ADDENDUM # 2

Bid 17C8, Butterfly Ridge Elementary School – New School Construction
REVISED DUE DATE: January 26, 2017

BUTTERFLY RIDGE ELEMENTARY – NEW SCHOOL CONSTRUCTION

**BUTTERFLY RIDGE ELEMENTARY SCHOOL
BID PACKAGE
ADDENDUM NO. 2
21347.00**

C18 VOCAL MUSIC- EAST ELEVATION

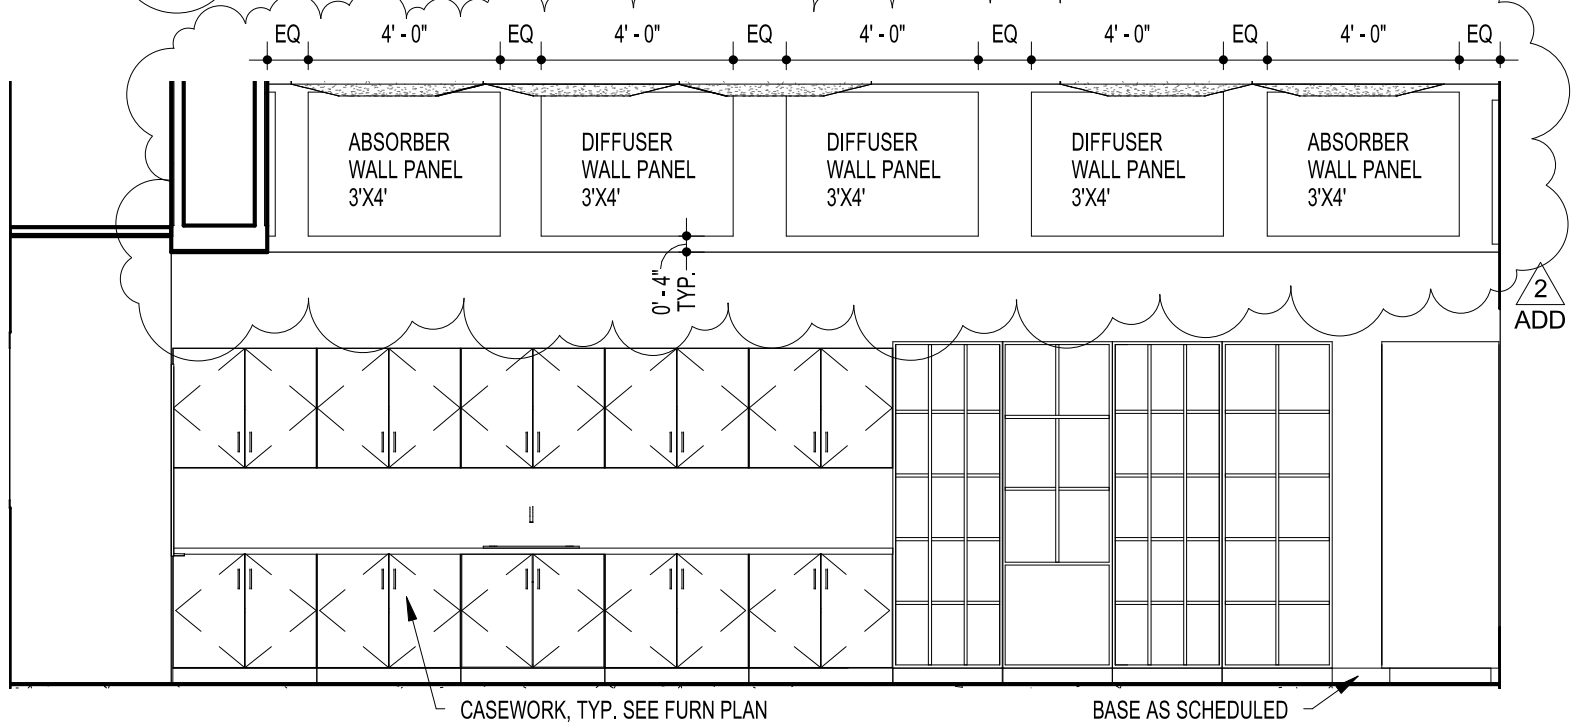
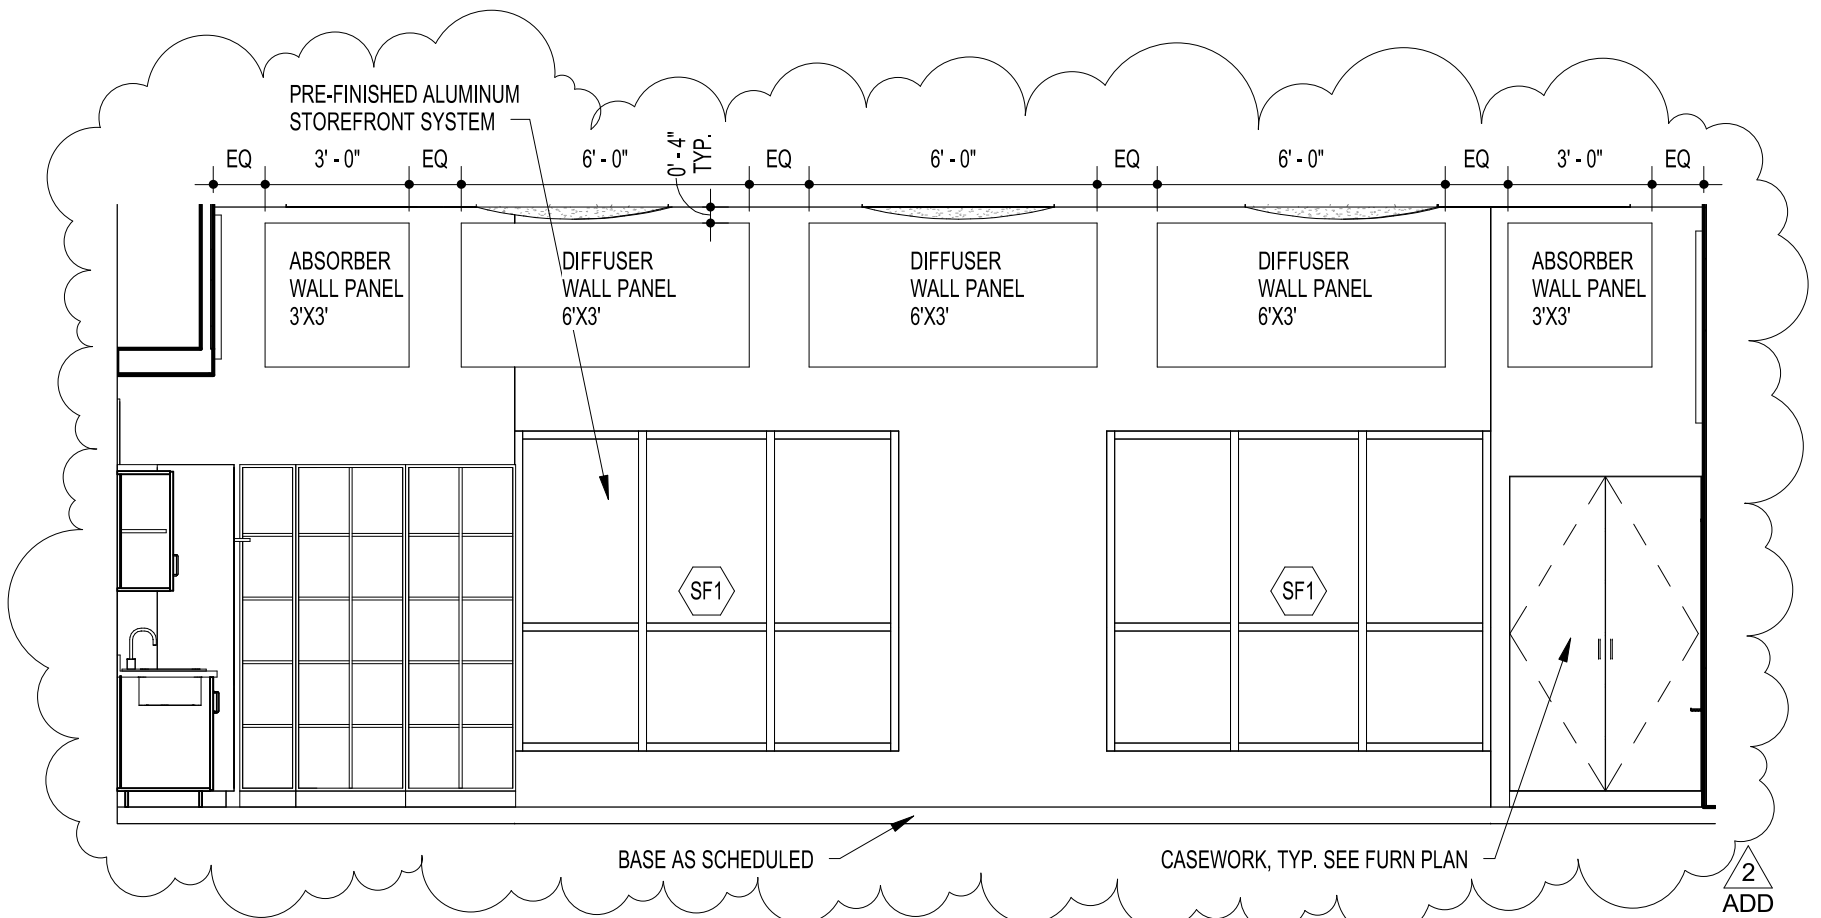
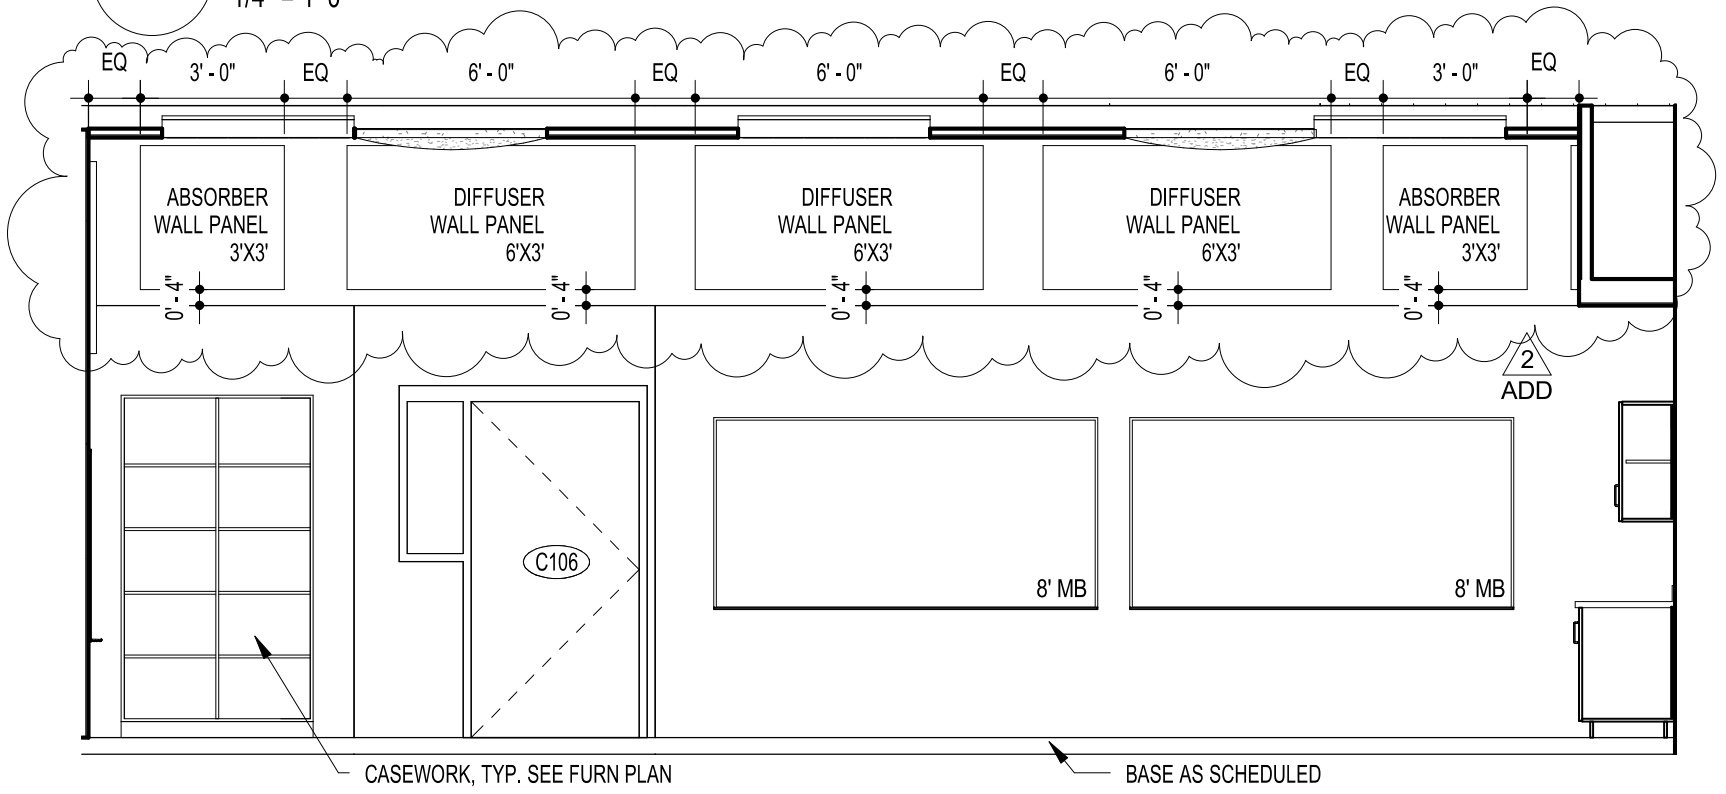
.PB027	Vocal Music C106 - Acoustic Wall Panels	Lend Lease	Grimm + Parker	01/05/17	01/12/17	01/09/17	(3)
<p>Wenger Corporation: Drawing A-6.2 Views G18, E18, C18, & A18 appear to have acoustic wall panels, but they are not labeled. Can the architect supply a drawing with the wall panels labeled as to which type they are? Drawing A-6.2 View G18 appears to have acoustic wall panels partially covering the aluminum storefront system, and the view does not go all the way up to the ceiling. Can the architect supply a drawing showing the entire elevation and clarify the size and location of the acoustic panels?</p>			<p>[1/9/2017 Grimm + Parker - Don Porter] Panel information has been provided in Addendum 2.</p>				
.PB028	Instrumental Music C106B - Acoustic Wall Panels?	Lend Lease	Grimm + Parker	01/05/17	01/12/17	01/06/17	(6)
<p>Wenger Corporation - There isn't an interior elevation for Instrumental Music C106B. Are there any acoustic wall panels in this room? If so, can the architect supply interior elevations for this room?</p>			<p>[1/6/2017 Grimm + Parker - Don Porter] No acoustic panels are required in C106B. This is clarified in Addendum 2.</p>

- ITEM NO. A12: SHEET A-6.1 INTERIOR ELEVATIONS
REVISE Elevation J14 per attached sketch SKA-2.4.
- ITEM NO. A13: SHEET A-6.2 INTERIOR ELEVATIONS
REVISE Elevations A18 and C18 per attached sketch SKA-2.5.
REVISE Elevations E18 and G18 per attached sketch SKA-2.6.

ADD 2
SKA-2.8

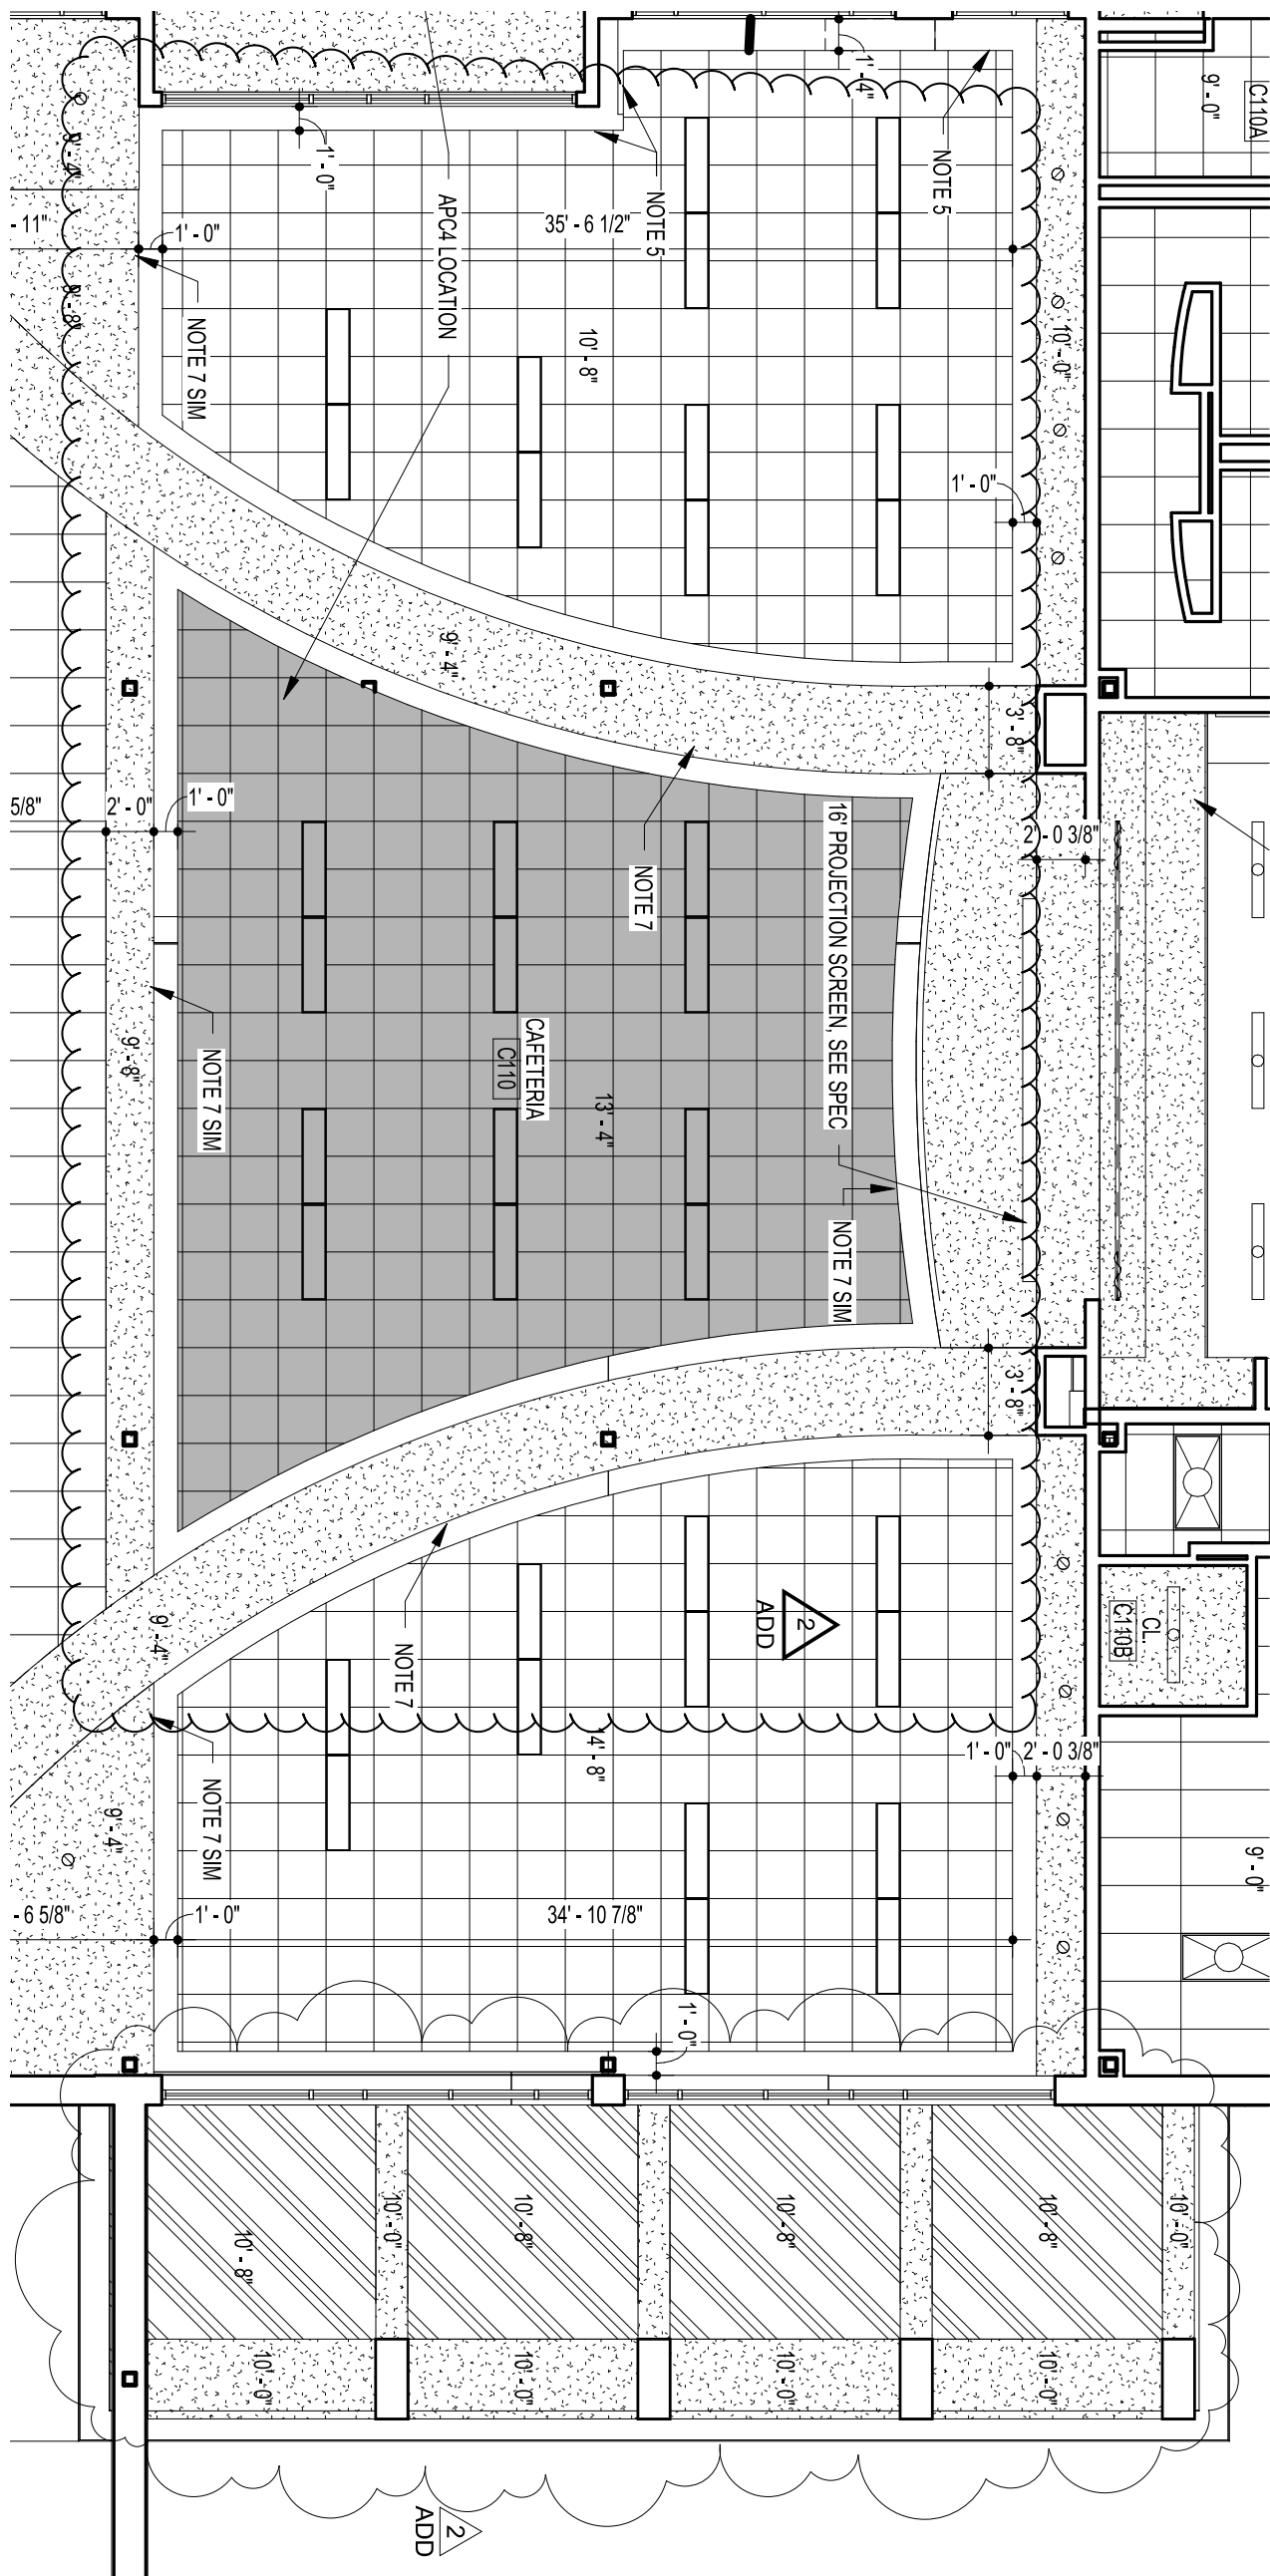
- ITEM NO. A14: SHEET A-7.1 REFLECTED CEILING PLAN-FIRST FLOOR-AREA A
REVISE Plan A16 per attached sketch SKA-2.7.
- ITEM NO. A15: SHEET A-7.2 REFLECTED CEILING PLAN-FIRST FLOOR-AREA B
REVISE Plan A16 per attached sketch SKA-2.8.
